Reference: **2112 Bel-Air Drive
Conceptual Site Servicing and Stormwater Management Report (Addendum)
Novatech File No.: 119000 / City Files: D07-16-19-0032 and D02-02-19-0142**

The following addendum is to be enclosed with the 2112 Bel-Air Drive, Conceptual Site Servicing and Stormwater Management Report, dated December 6, 2019.

This addendum highlights the revisions made to the proposed development at 2112 Bel-Air Drive and the impacts to the proposed servicing. The addendum also addresses the Engineering Peer Review comments dated February 19, 2020 to advance Draft Plan approval.

**MACRO GRADING, EROSION AND
SEDIMENT CONTROL PLAN**

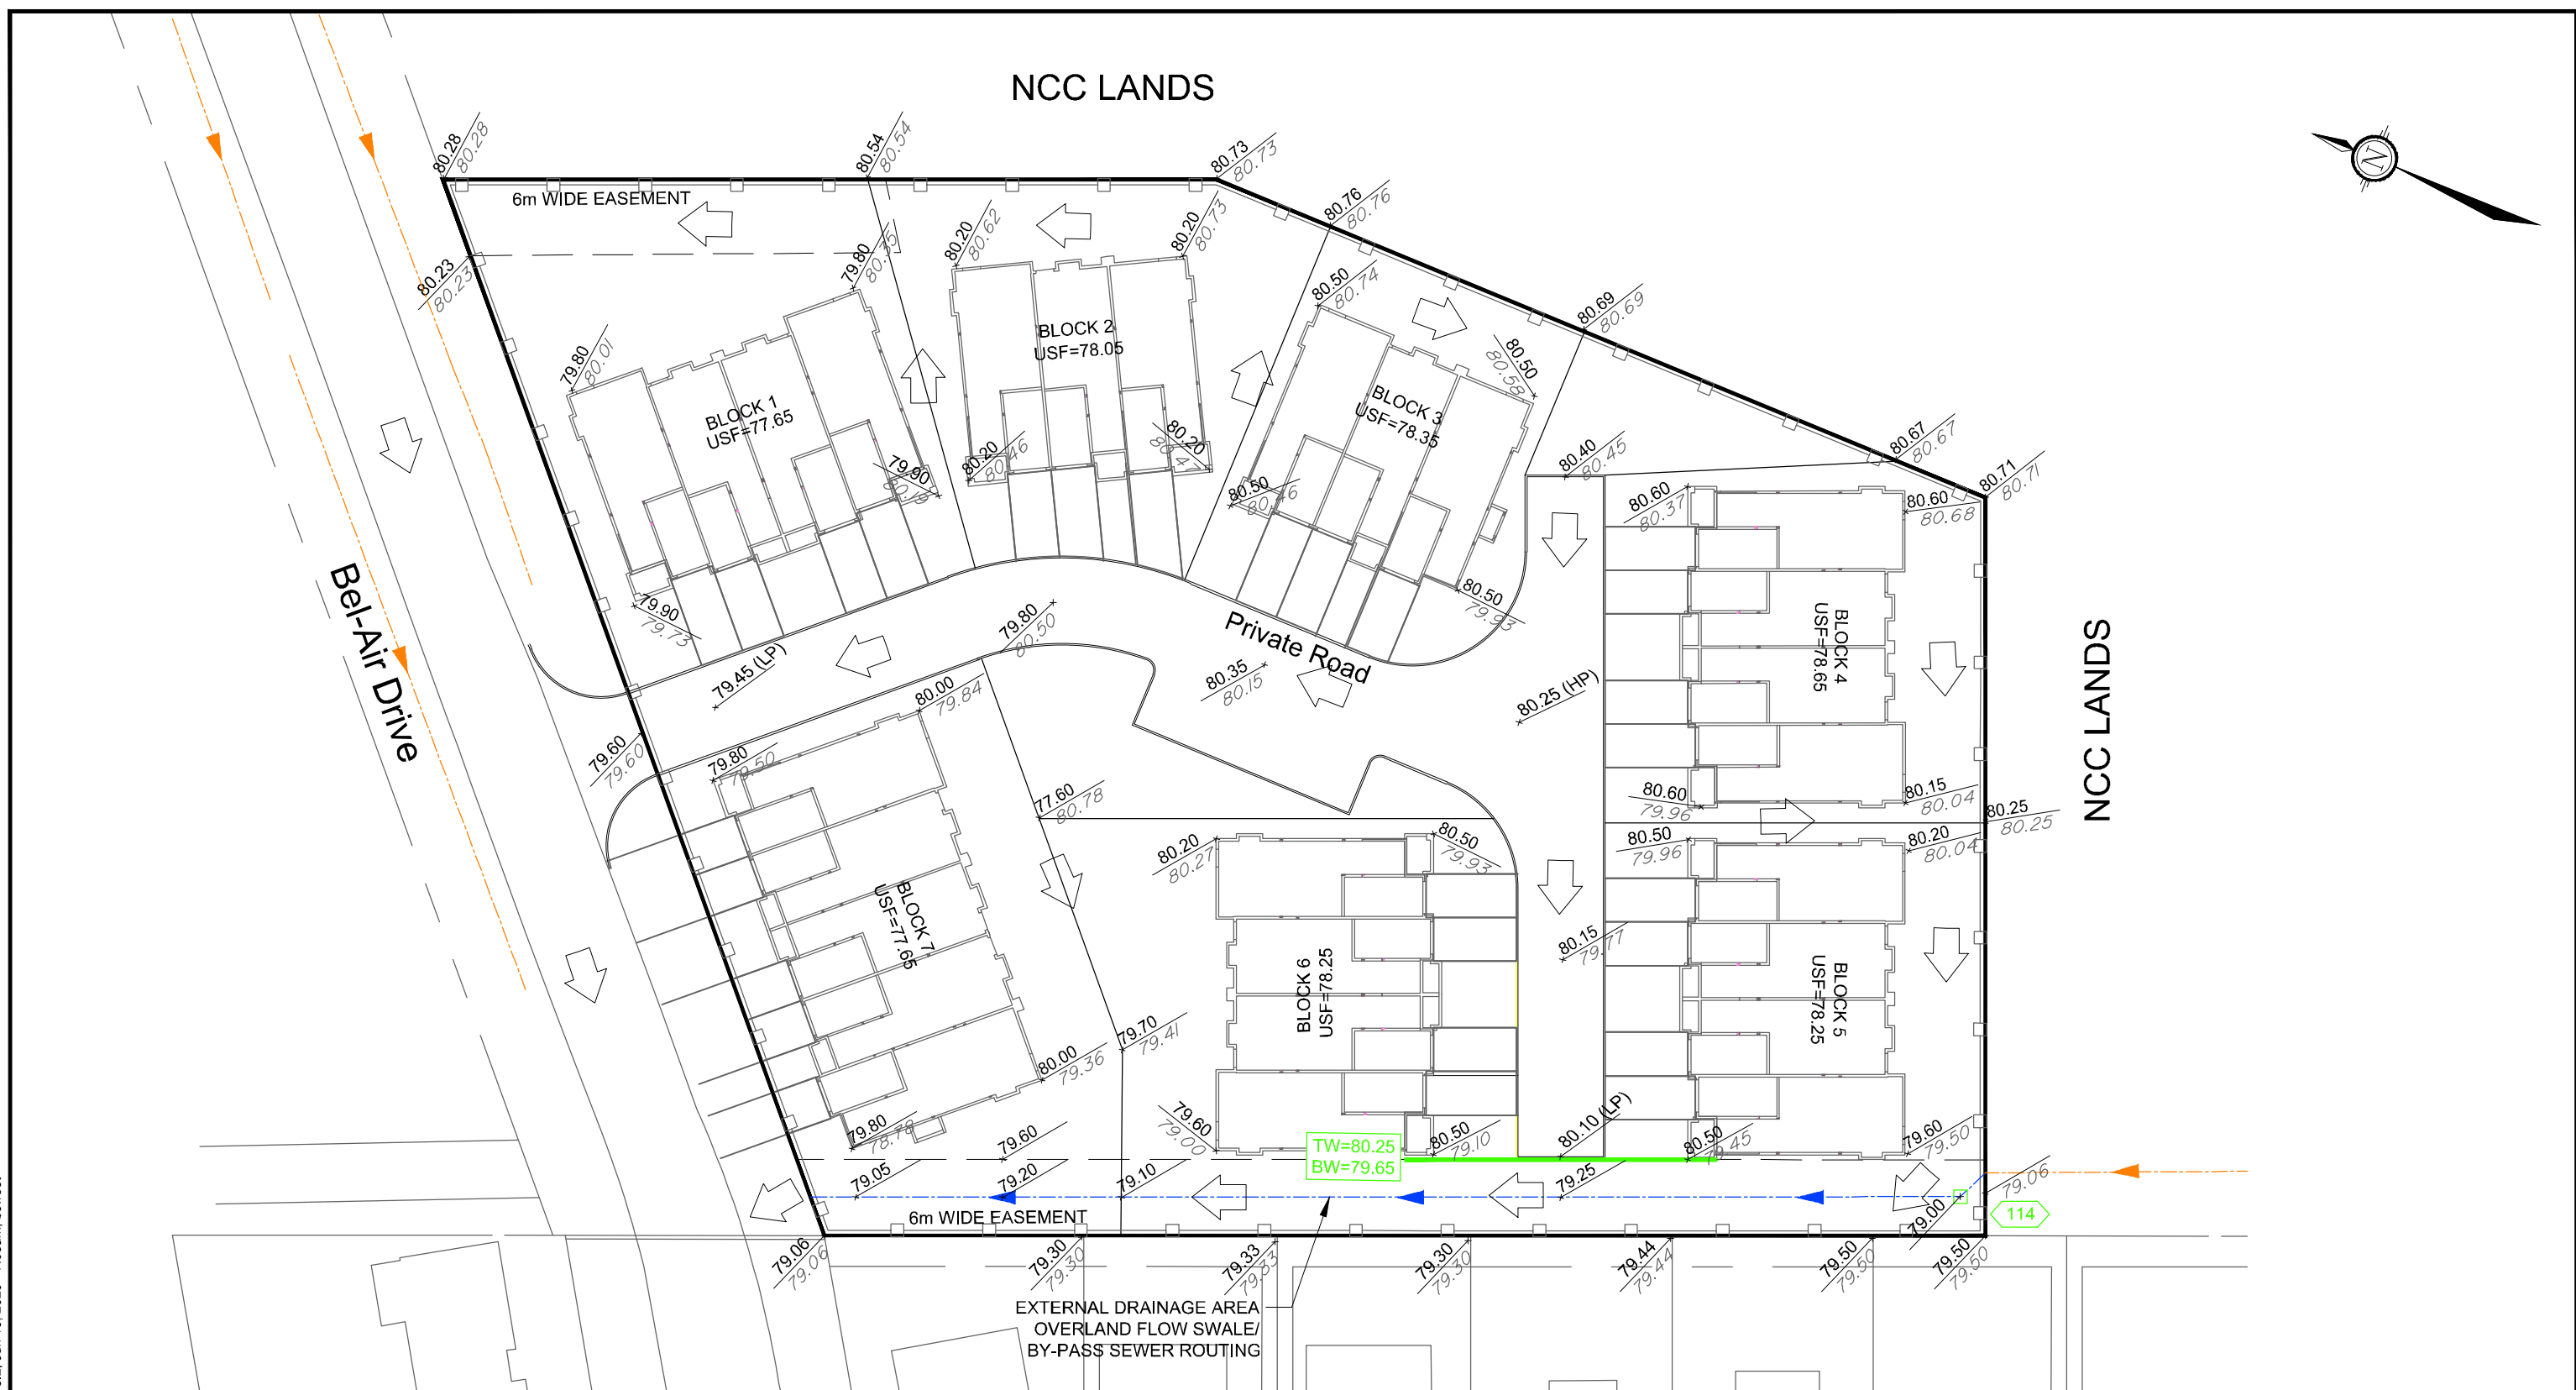
The proposed servicing and grading have been updated to reflect the revisions made to the Subject Site. Refer to **Figure 3.1** – Proposed Servicing Layout Plan and **Figure 3.2** – Macro Grading, Erosion and Sediment Control Plan.

Further to the Serv&SWM Report, and to ensure minimal impact to the NCC Lands as well as the rear yards of the homes along Field Street, the following is now being proposed:

- The 375mm by-pass sewer will convey the frequent storm events up to and including the 25-year event from the external area (Area B01);
- An overland flow swale will convey flows greater than the 25-year event (ie. 50-year, 100-year, and stress test events) from the external area (Area B01);
- Although it appears that the majority of the rear yards of the homes along Field Street are being directed to Field Street, the external area (Area B01) will be revised to include half of the rear yard areas to account for additional flows in the event rear yards are regraded in the future. The proposed by-pass sewer/overland flow swale will be sized accordingly.
